**Re: Application for a Permissive Change Filing with FCC ID: EW780-0144-00**

The purpose of this document is to describe all the changes that are made on **baby Unit** to the new designed family models **DM225 BU** from the original model **DM223 BU** in order to meet the requirements.

DM223 BU RF layout (35-200534-004-100)

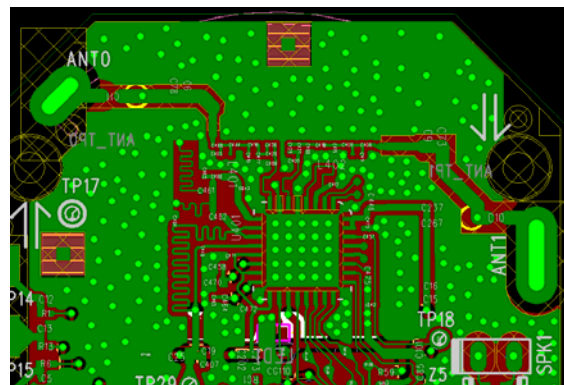
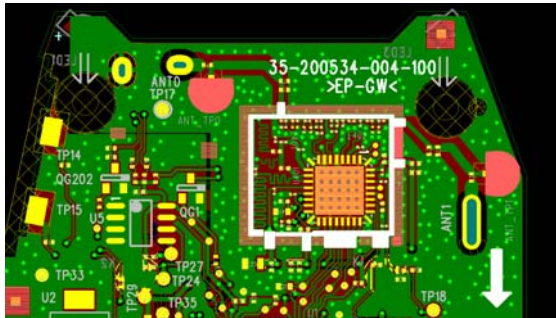
- **Non-RF circuit and its layout**
- **RF matching circuit and its layout**
- **Antenna size and location**
- **The no. of the antenna—DM223 BU has 2 antennas while DM226 BU has one only;**  
In the original model, the two antenna will not do the transmit/receive at the same time but with the antenna diversity that it will select the better antenna to the transmit/receive.
- **External appearance**

- RF IC/circuit/layout
- Antenna type and gain
- No change in radio parameters has occurred.
- RF conducted and radiated emission level is similar.
